## **PLANNING AND ZONING COMMISSION AGENDA**

**STAFF REPORT  
KETCHUM PLANNING AND ZONING COMMISSION  
REGULAR MEETING OF OCTOBER 24, 2016**

**REVIEWER:** Brittany Skelton, Senior Planner

The applicant is requesting a Conditional Use Permit (CUP) to allow redevelopment of 911 N. Main for a motor vehicle fueling station and a food service establishment. Motor vehicle fueling stations and food service (subject to limitations on hours of operation and size) are only allowed in the LI-1 District if a Conditional Use Permit (CUP) is approved. The definition of motor vehicle fueling station permits retail sales of items of convenience to the motoring public. The Planning and Zoning Commission (Commission) has complete discretionary authority to approve, deny, or conditionally approve either use (fueling station or restaurant) or approve, deny, or conditionally approve both uses on the site, basing the decision upon findings of fact.

QUEUE LENGTH EXHIBIT

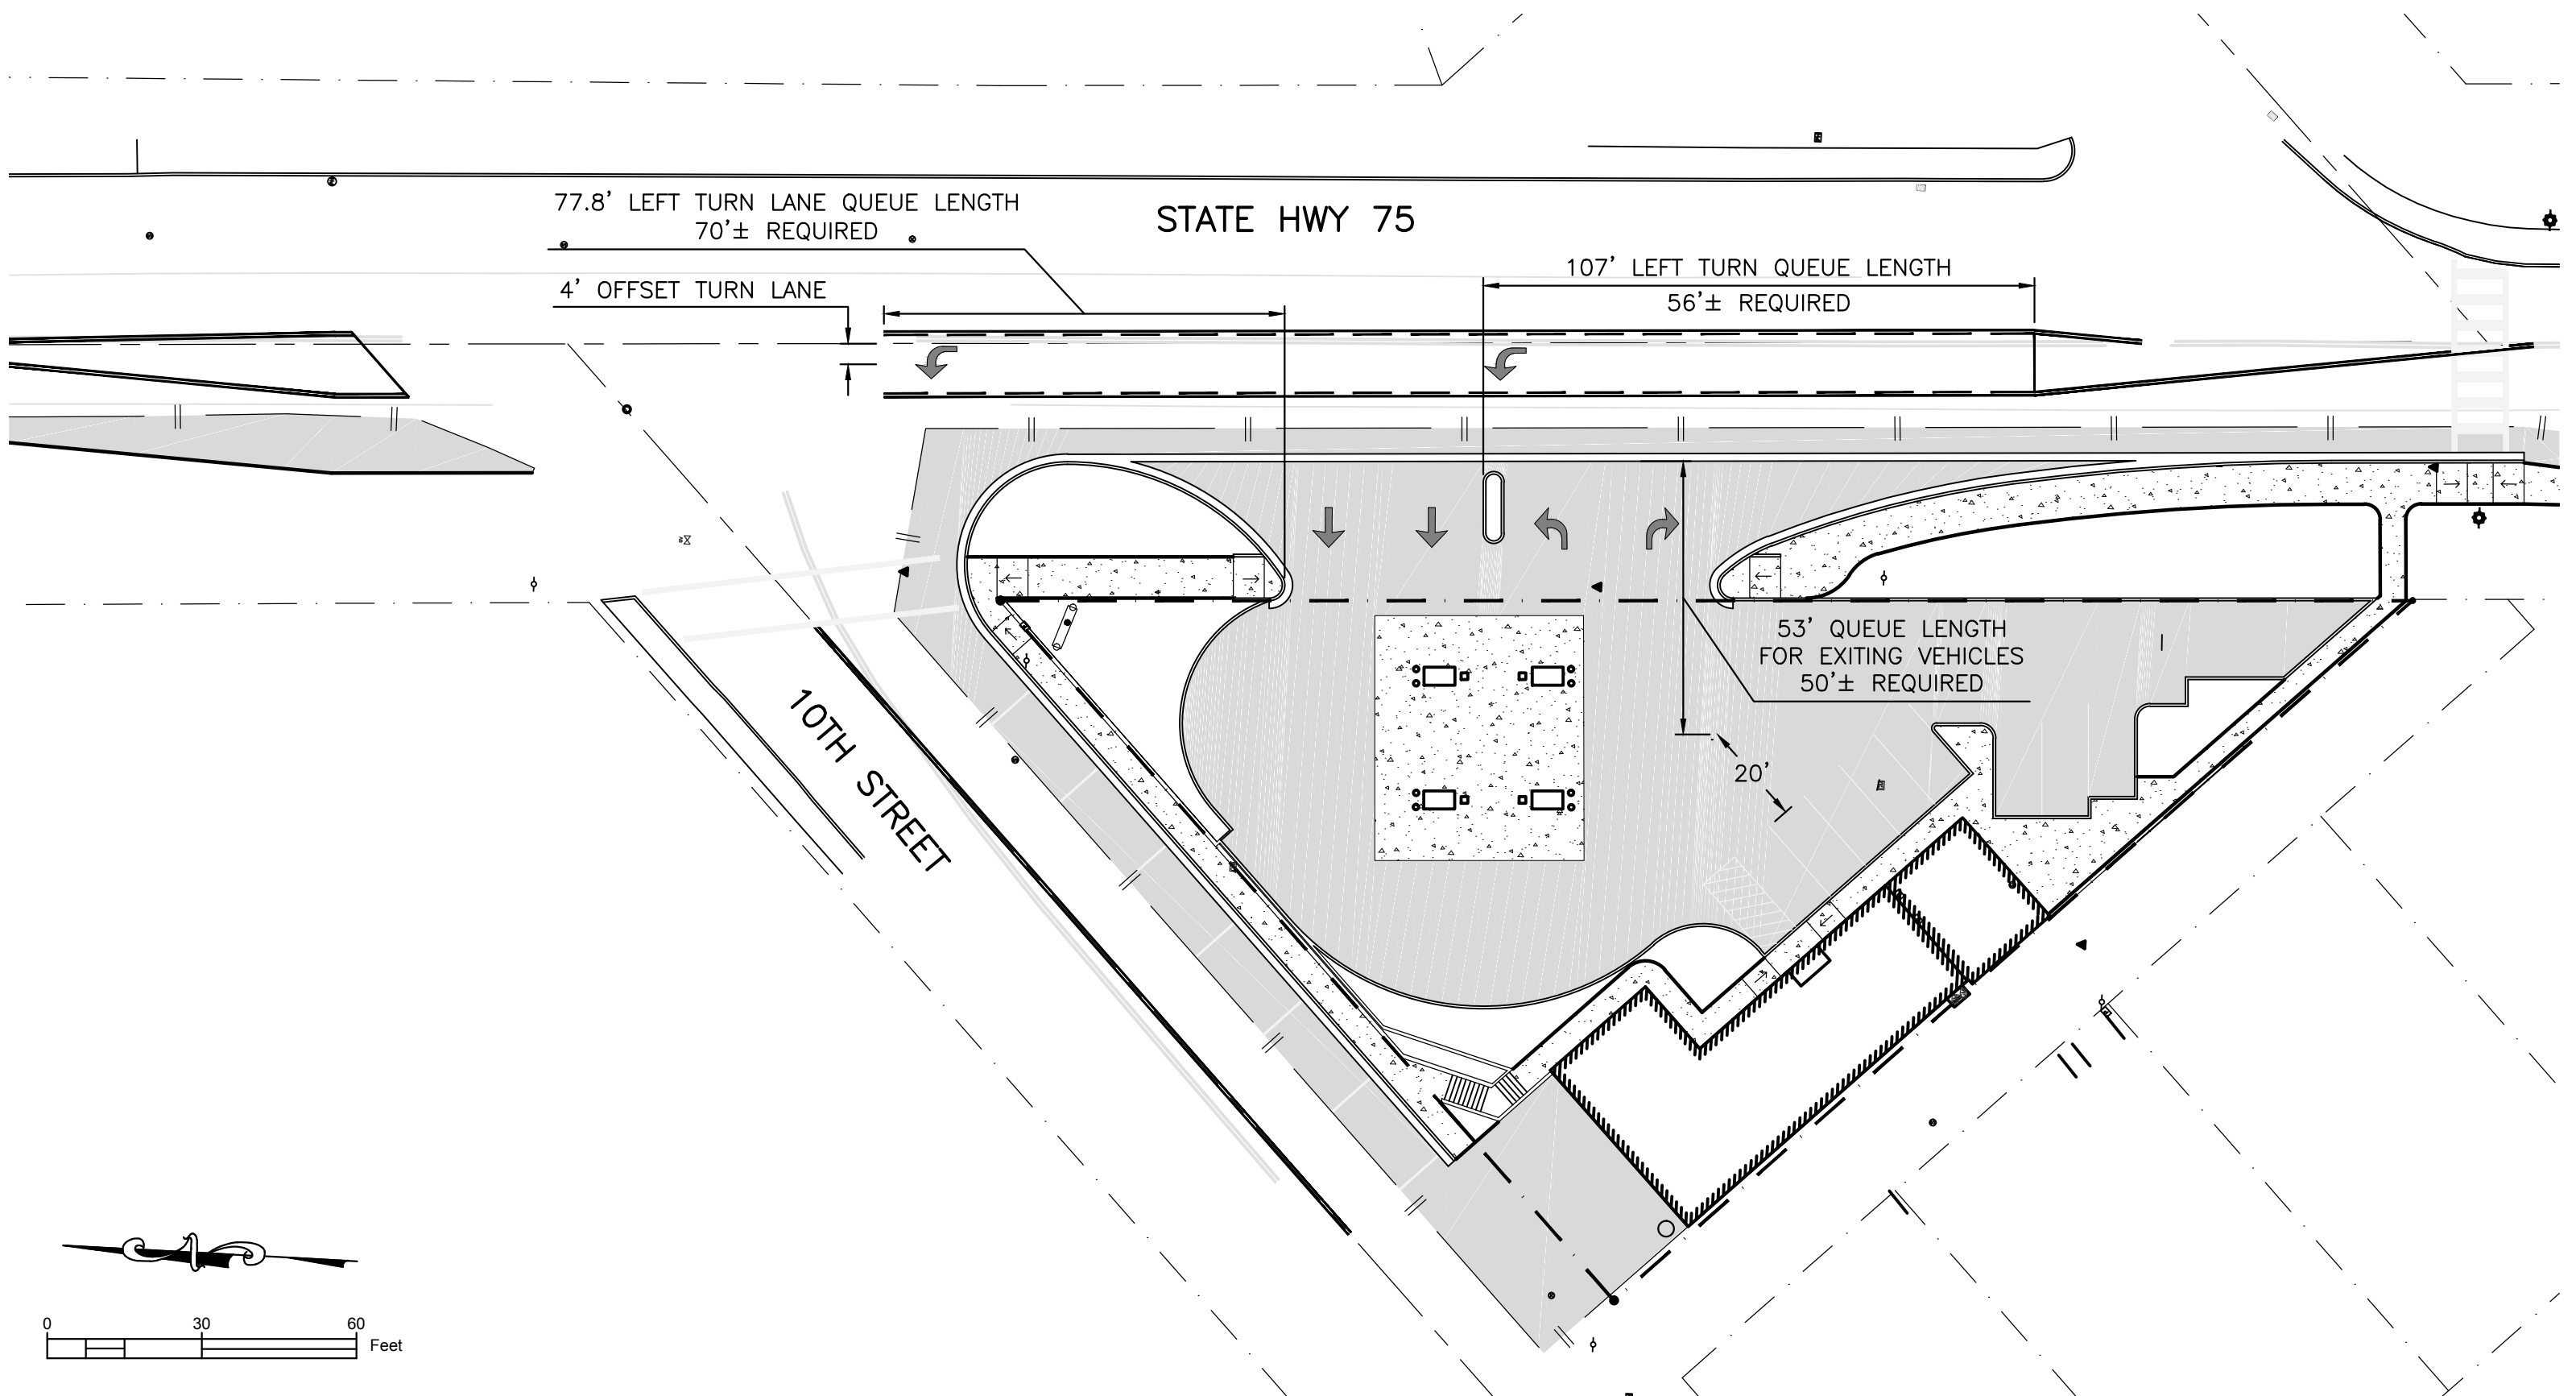
- a. The existing traffic study assumes there is an 80 foot stacking lane available for cars turning left. However, the stacking lane for cars entering into the project appears to be less than 80 feet as indicated on the Site Plan. Additionally, it appears the analysis only focuses on the delay and stacking for cars turning left onto 10th Street and does not take into account cars turning left into the project and how that impacts cars turning left on 10th Street. For instance, a car turning left onto 10th Street is not going to que behind a car waiting to turn left into the project.

PLOT DATE	
9/16/16	
SHEET NO.	
A-2

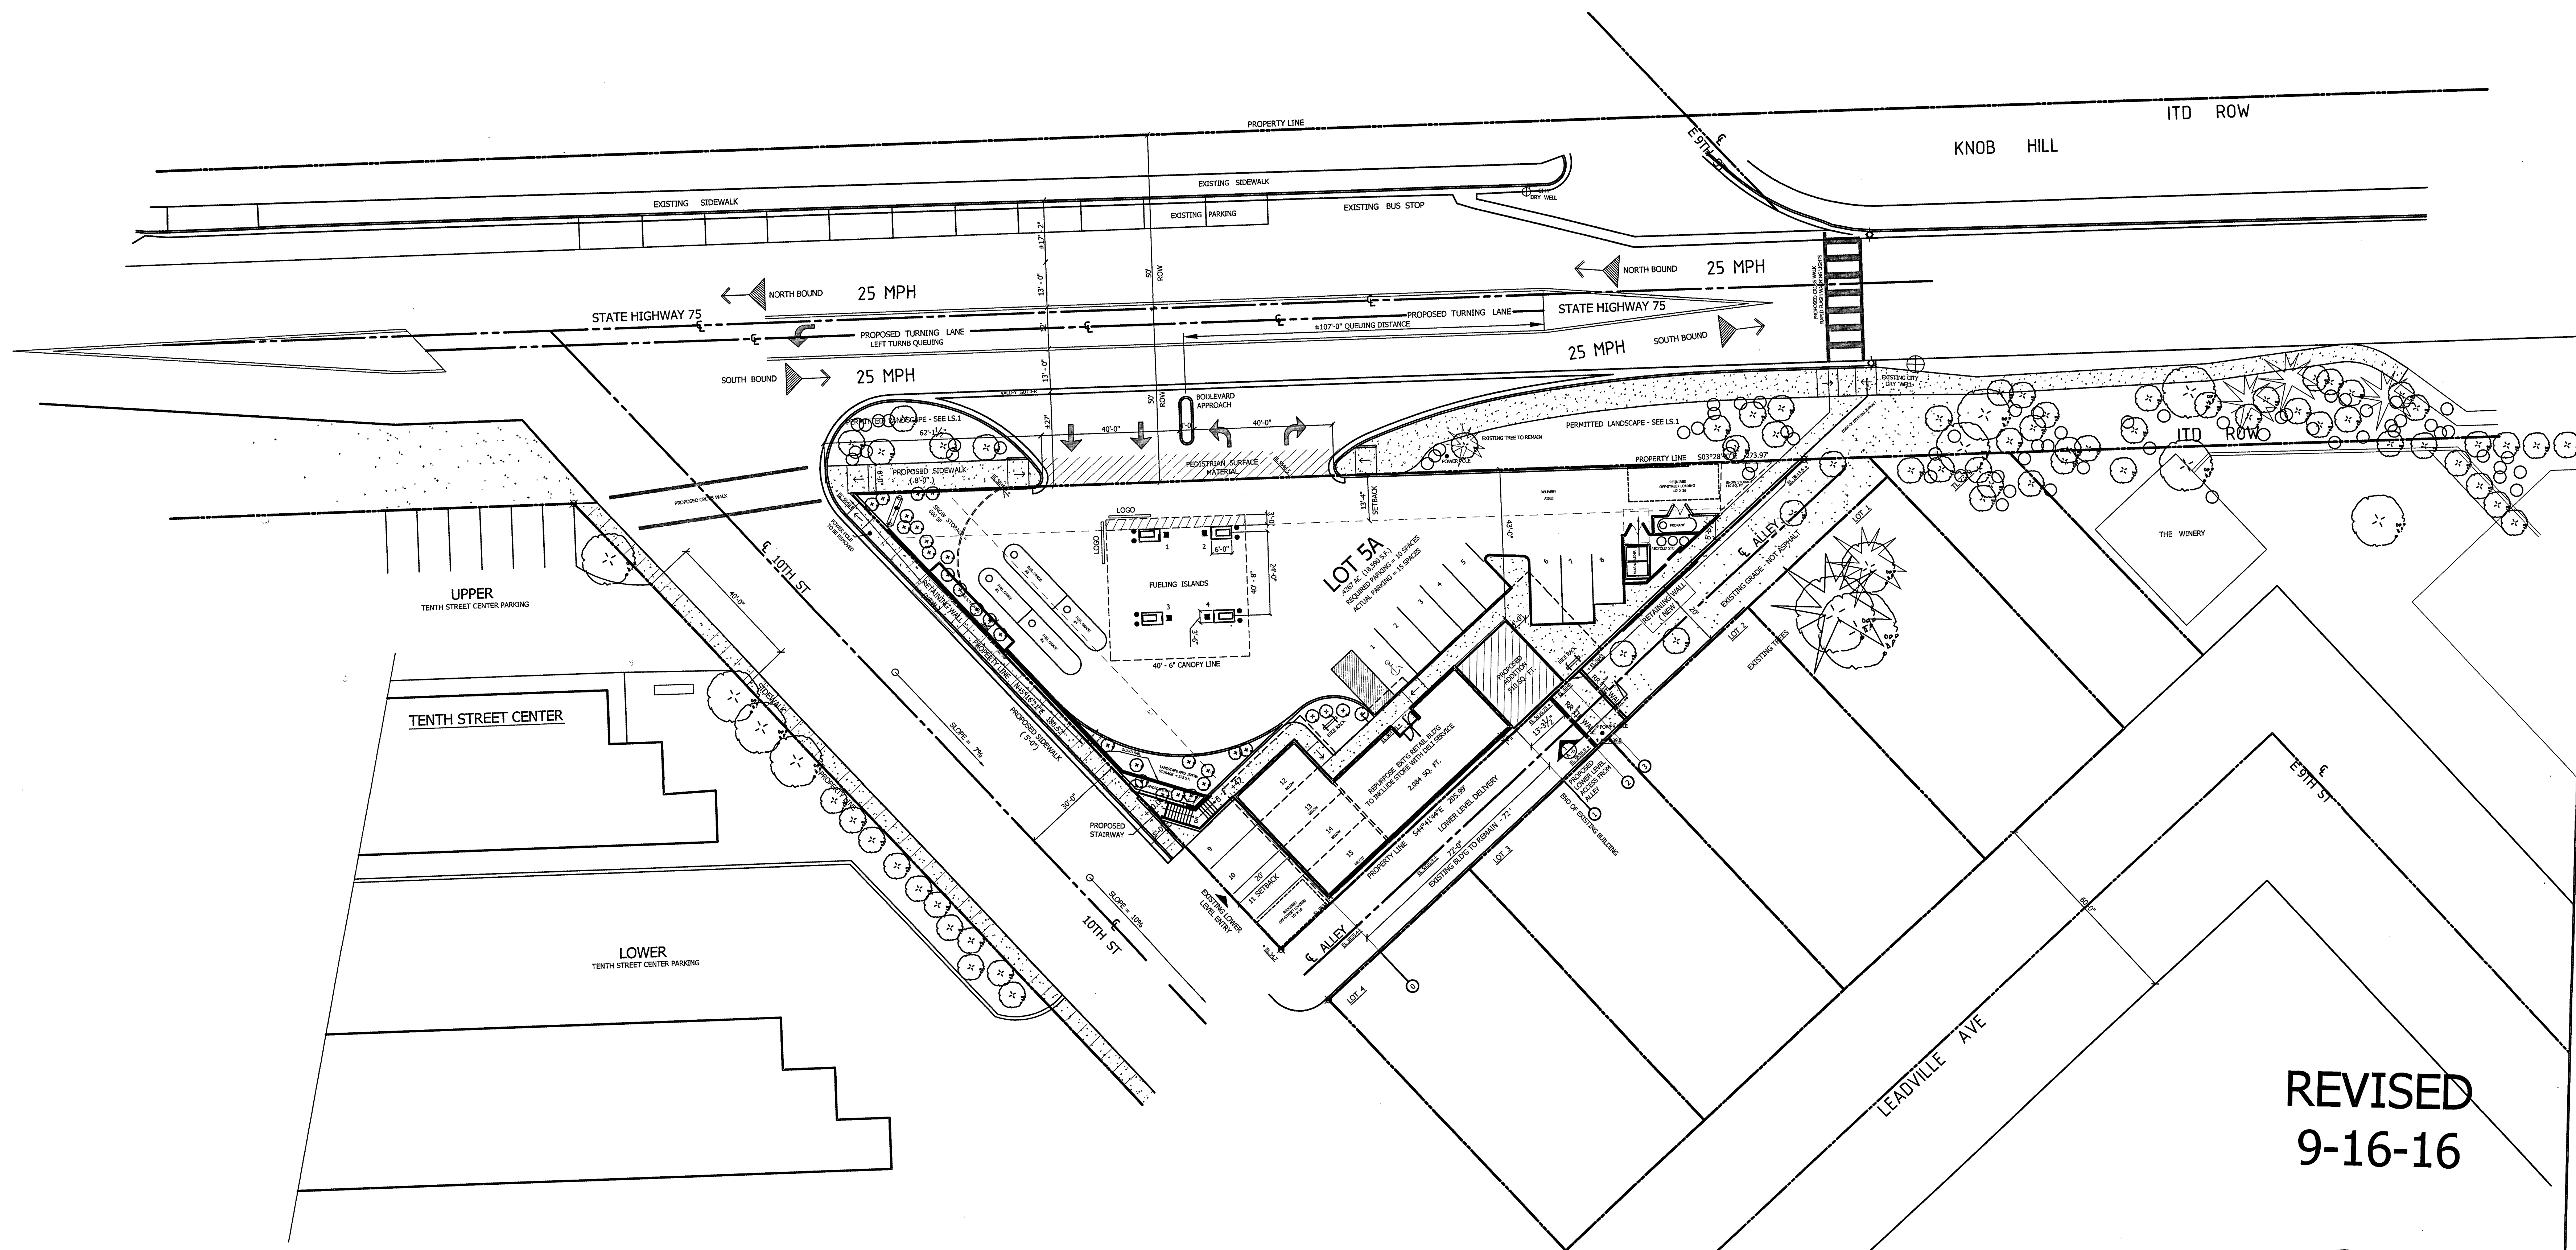
The Site Plan has been revised and now includes enhanced pedestrian access.
